Car Park Accessibility Review and Inclusive Design Framework

MIMA recommendations

YAF – 19 September 2023

Coppergate

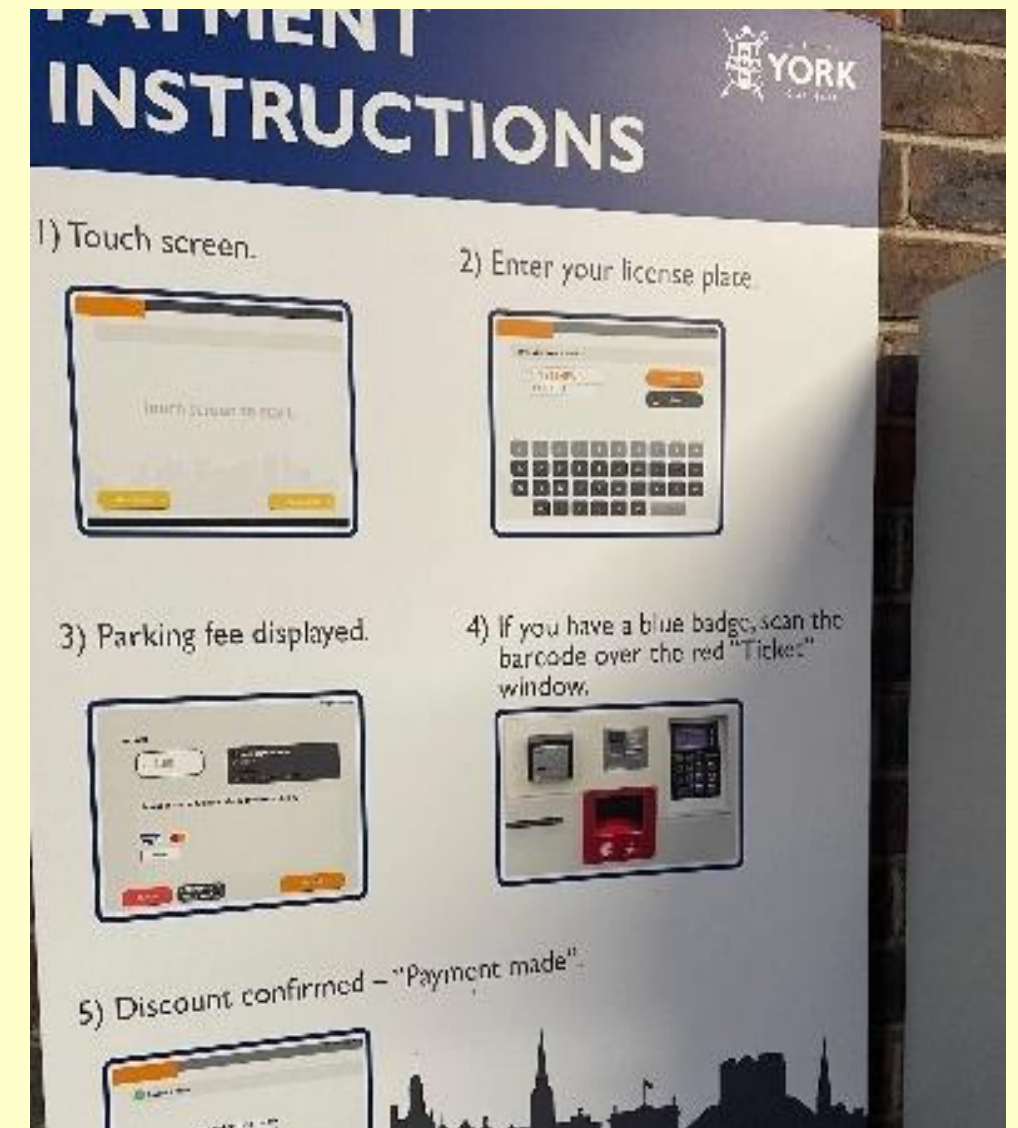
Issue – Lift access

- During MIMA's site visit, one of these lifts was out of order.

Recommended actions:

- Regularly maintain both lifts to ensure step-free access is provided to all levels of the car park at all times.
- In the event of the lift breaking down, ensure this is clearly communicated to visitors at the entrance of the car park.

Coppergate

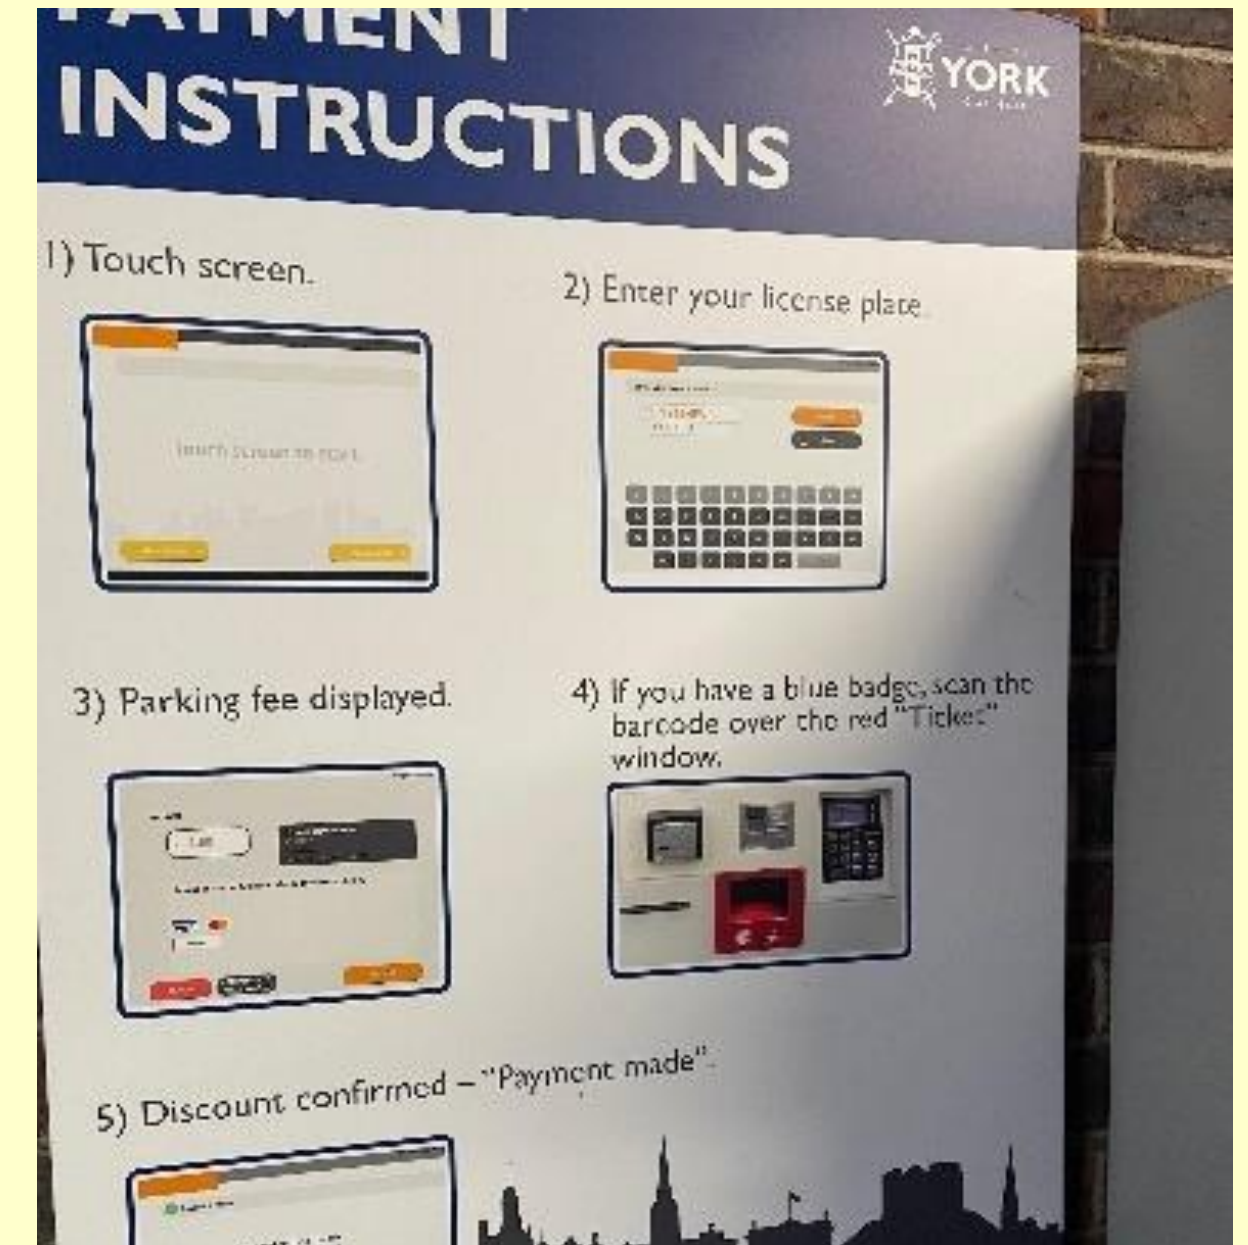
Issue – Payment machines (continued)

- Blue badge holders can scan their badge for free parking, however this means removing the blue badge from the car and returning it again.

Recommended actions:

- Review process to avoid additional journey.

Coppergate

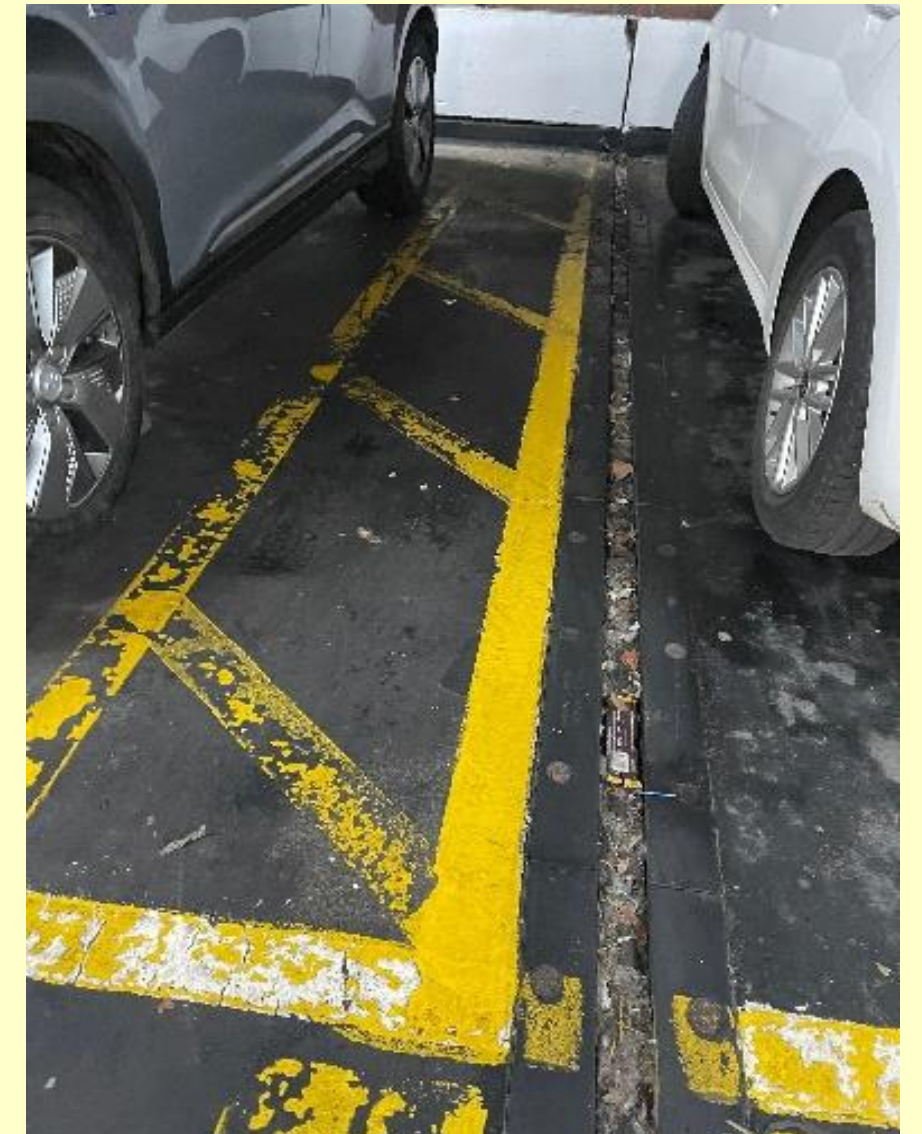
Issues – Accessible parking bays (Levels 1 and 2)

- Accessible bays and access zones are not to current access standards

Recommended actions:

- Accessible parking bays should be reconfigured to meet current access standards

Coppergate

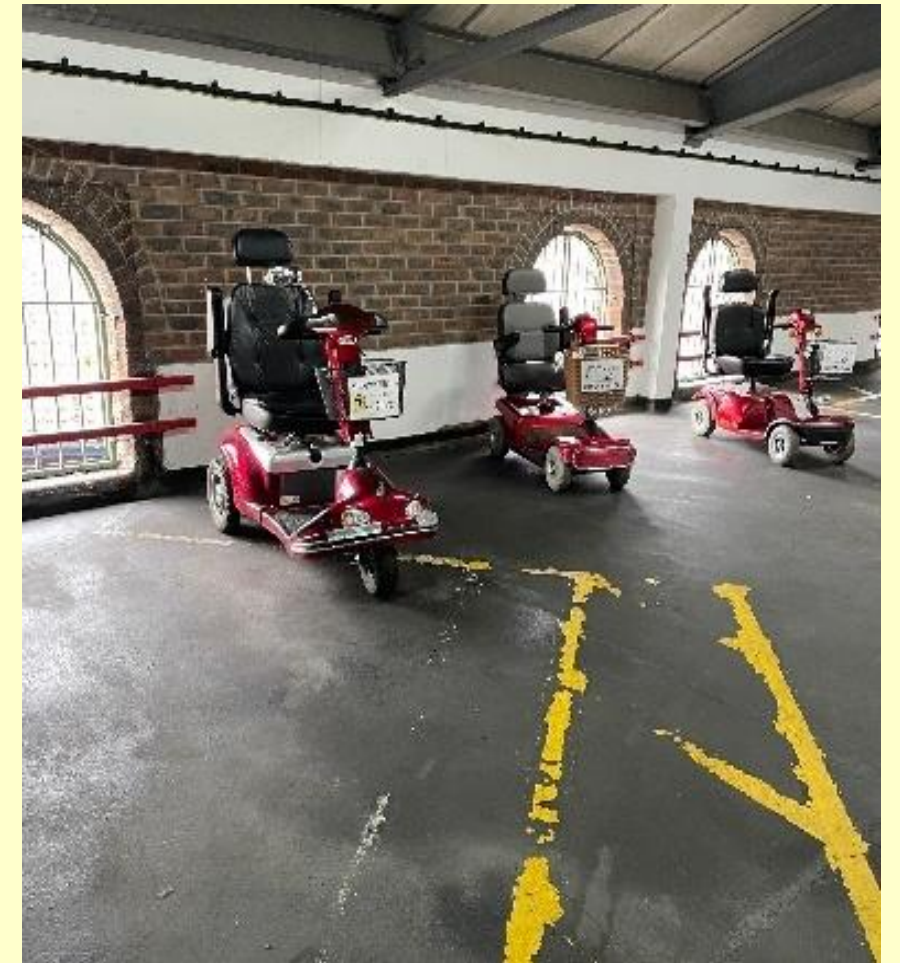
Issue – Accessible parking signage

- Lack of visibility of signage for blue badge holders, provided at 390mm-650mm above the ground.

Recommended actions:

- Provide signage at heights in which the lower edge is 1000mm above floor level.
- New signage should read 'Blue Badge Holders' rather than 'Disabled Badge Holders'

Coppergate

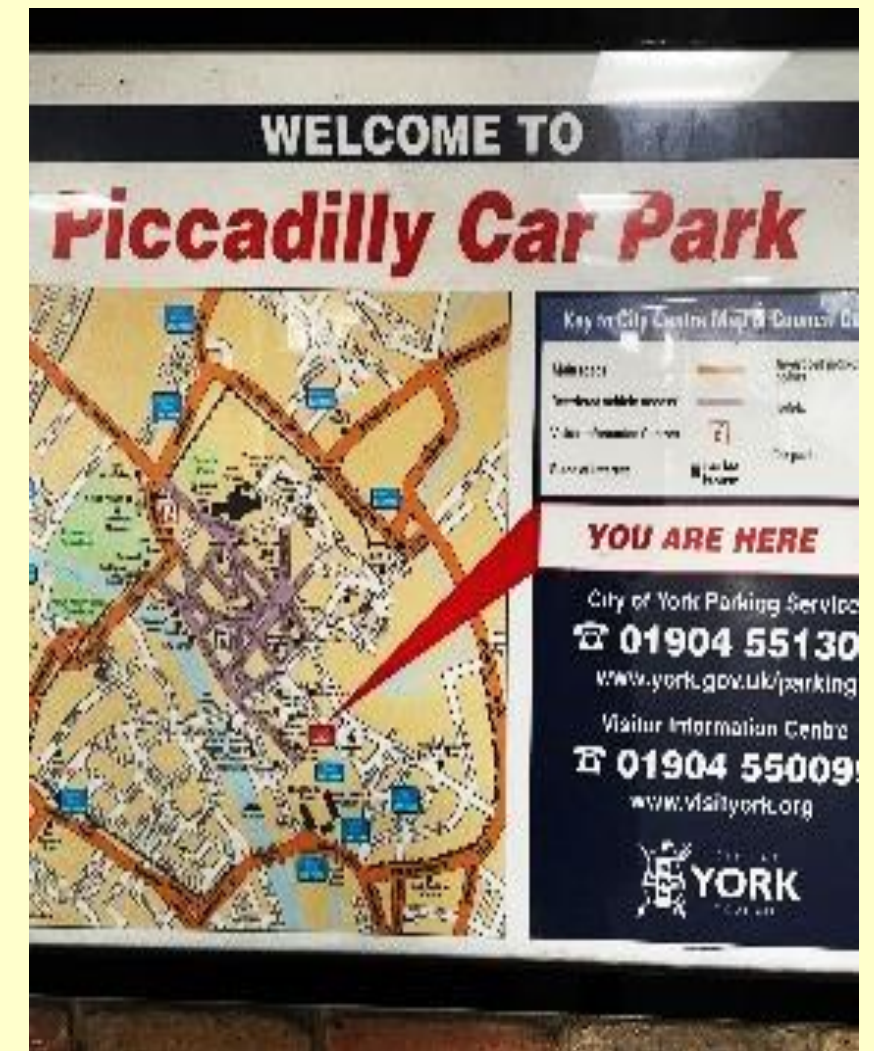
Issue – General signage

- Coppergate car park provides directional signage and maps to aid wayfinding. However, these utilise old naming conventions and are inaccessible in their nature, particularly for those with visual impairment

Recommended actions:

- Review signage to improve legibility and provide consistent signage (style, layout, positioning and colour)

Castle car park

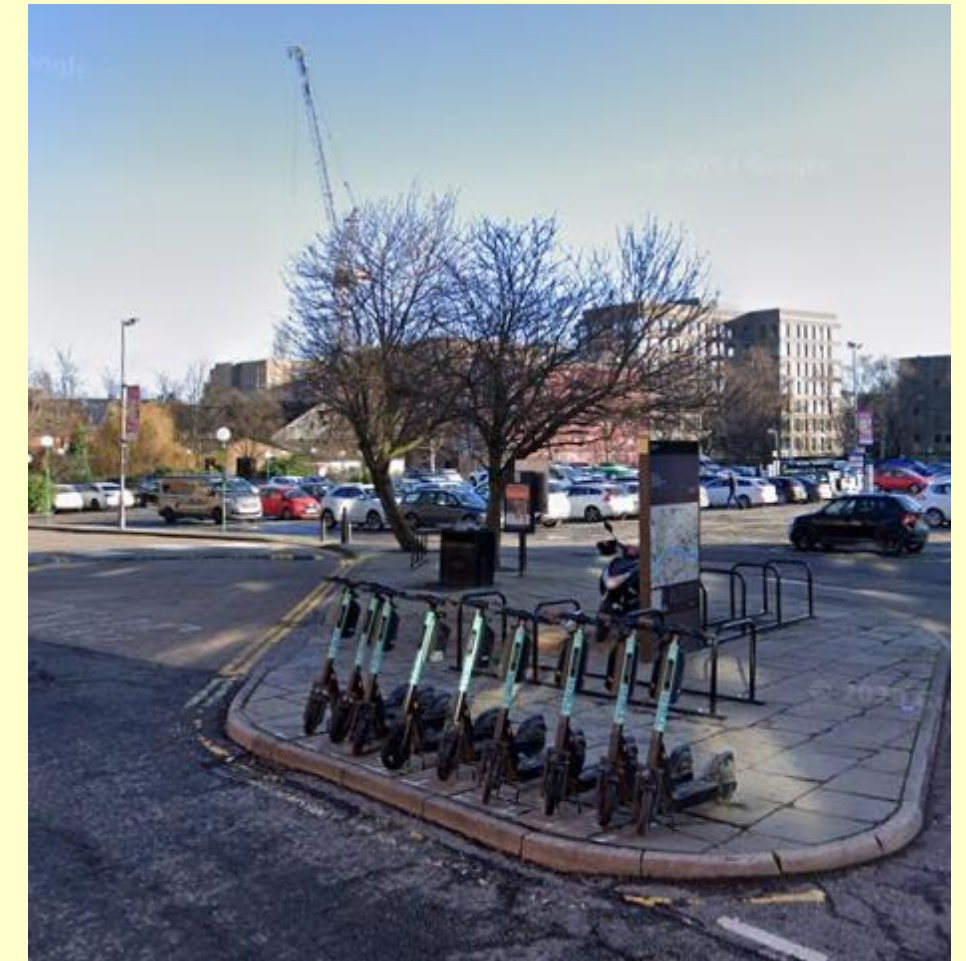
Issue – General

- Plans for Castle Gateway regeneration may result in the closure of Castle car park

Recommended action:

- It is recommended that all of the accessible parking bays are retained within Castle car park, should the rest of the provision be closed.
